ENGINEERING CHANGE NOTICE NO. 03724

DWG NO. 646.3300

DWG TITLE: UPPER CUTTER ASSY

ENGINEERING CHANGE NOTICE NO.		02196		SHEET 1 OF 2	
DWG NO.	646.3300	REV: N/C	PREPARED BY	S. HUFF	DATE: 01/05/09
DWG TITLE:		UPPER CUTTER ASSY			
APPROVED BY:	ENGR <i>[Signature]</i>	MFC <i>[Signature]</i>	QC	<i>[Signature]</i>	EFF: NEXT ORDER
TRANSACTION CODES (TC) A-ADD C-CREATE R-REVISE D-DELETE		REASON: REMOVED RIVETS IN FAVOR OF ADDITIONAL SCREWS			
		EFFECT ON DWG ☐ INC. ☒ UNINC.

SHEET 4, ZONE B8 IS:

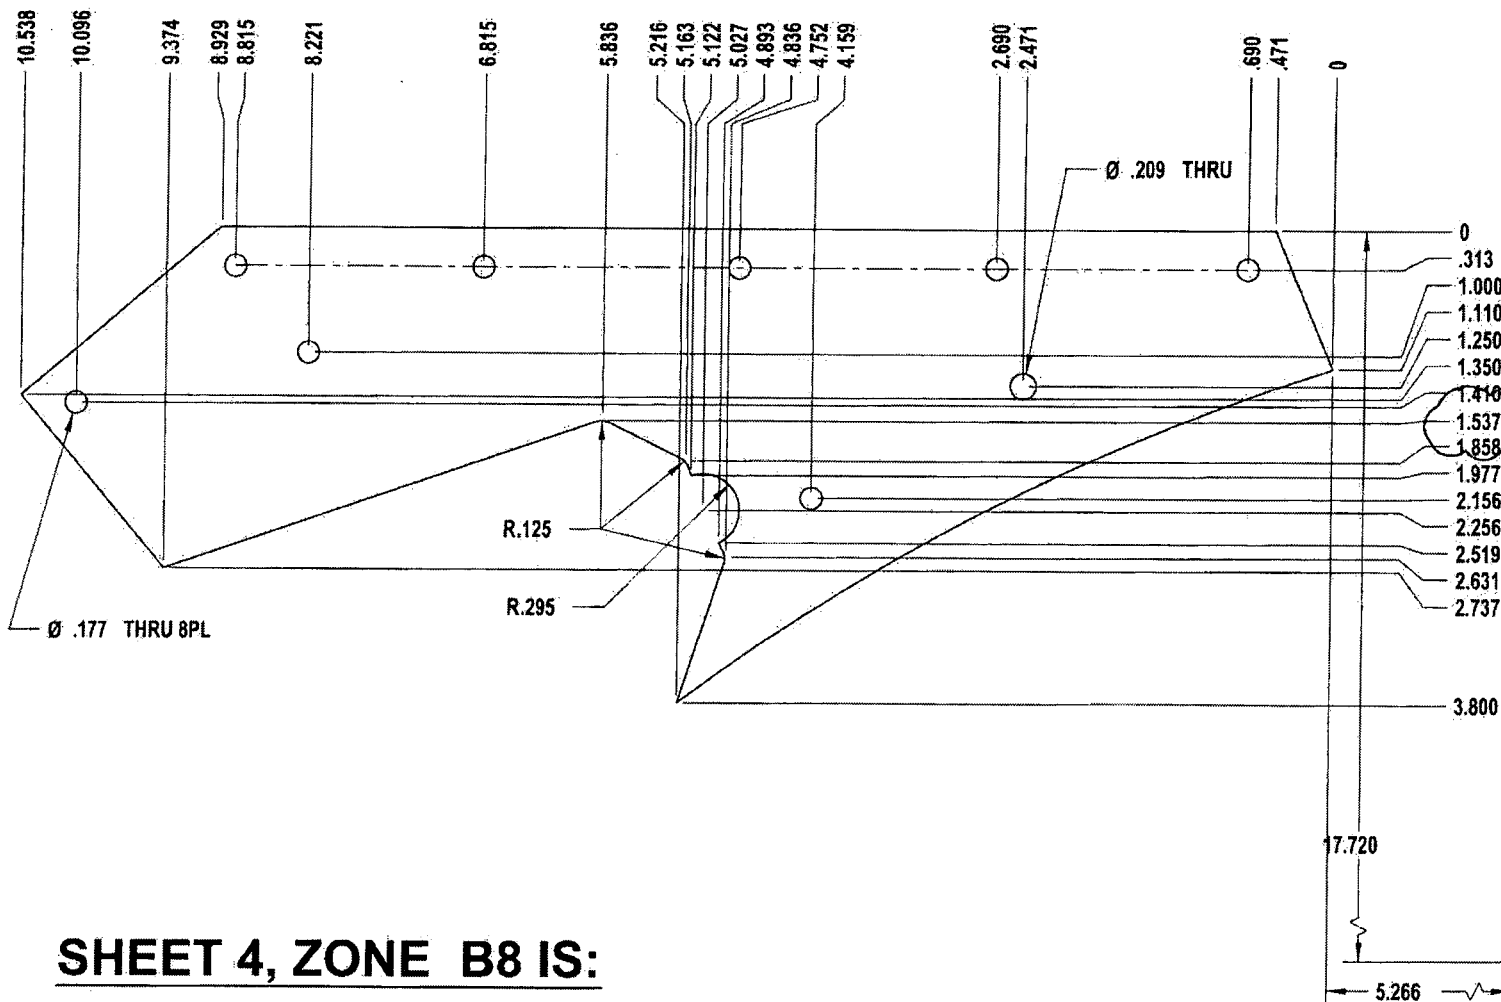
REASON:

REVISED ORDINATE DIMENSION.

SHEET 1, VIEW 646.3301, IS:

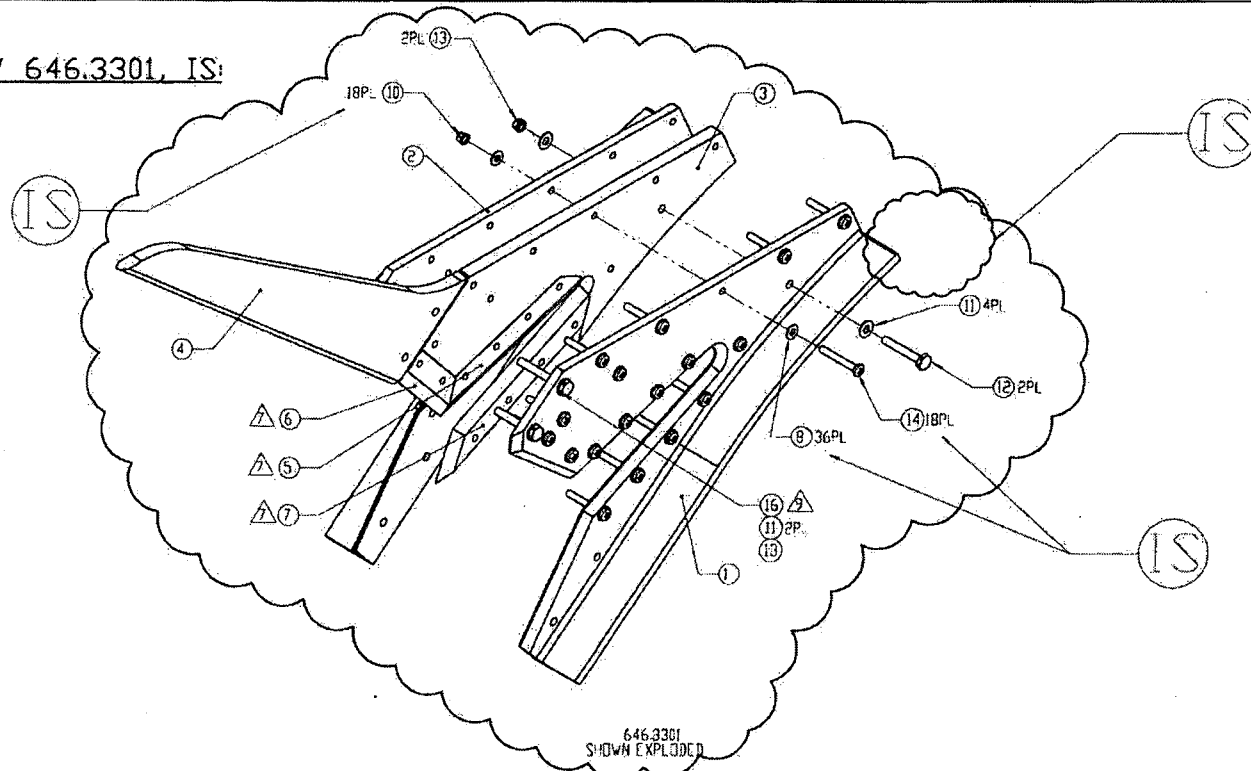
14	R	601.2765	18	SCREW	MS27039-0819
10	R	601.1541	18	LOCKNUT	MS21042L08
9	D	601.2766	3	RIVET	MS20470AD5-18
8	R	601.2764	36	WASHER	NAS1149FN832P
			3301		
F/N	TC	PART NUMBER	QTY	DESCRIPTION	MATERIAL/SPECIFICATION
DOCUMENTS EFFECTED:				CHANGE CATEGORY	DER REVIEW REQUIRED
☐ MDL ☒ INSTALL INSTRUC ☒ ICA ☐ FMS ☒ BOM				☐ MAJOR ☒ MINOR	☐ YES ☒ NO

SHEET 3, SECTION VIEW A-A, IS:

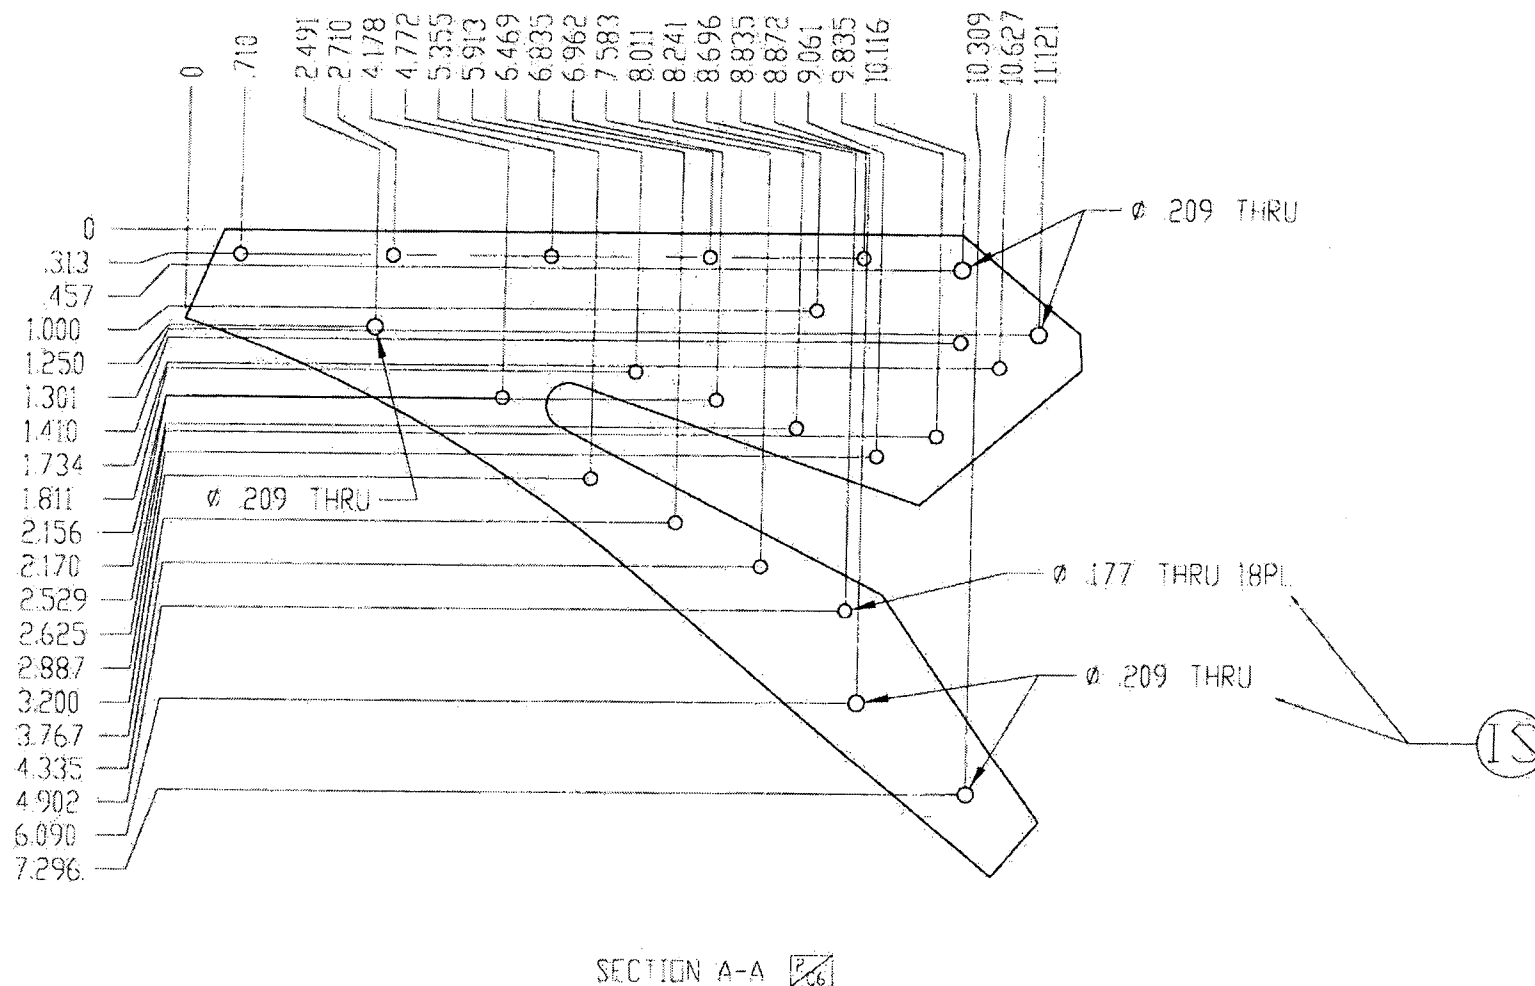
F/N	TC	PART NUMBER	QTY	DESCRIPTION	MATERIAL/SPECIFICATION
